SERVICE INSTRUCTION - PAC

Intercoolers for ROTAX® Aircraft Engines

ATA System: 73-10-00 Intake

In the course of continuous development and standardization, intercoolers (part no. 888963, 888965 and 888967) have been introduced as an optional extra part.

Fig. 3

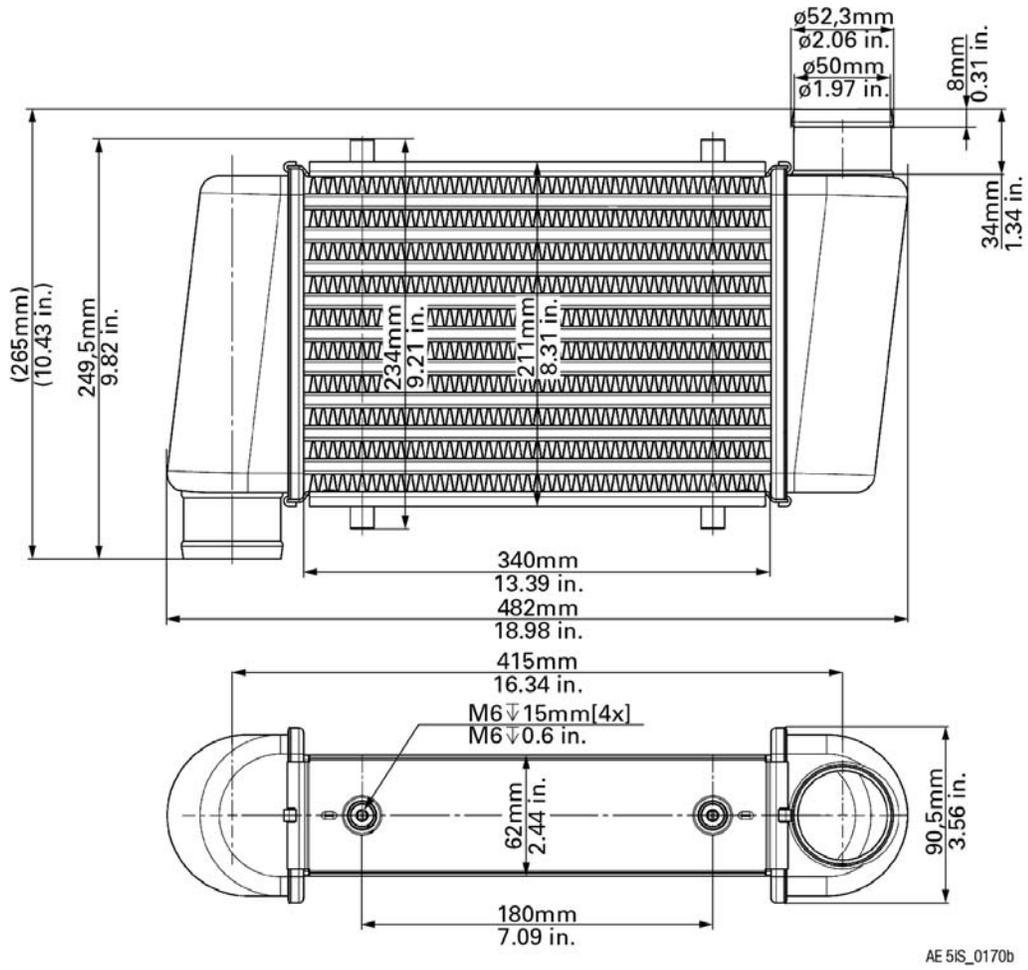
In comparison to the standard delivery intercooler (part no. 888962), the optional intercoolers differ in the following ways. See Fig. 1 to Fig. 4.

- Modification in the dimensions of the intercooler
- Orientation of inlet and outlet fittings
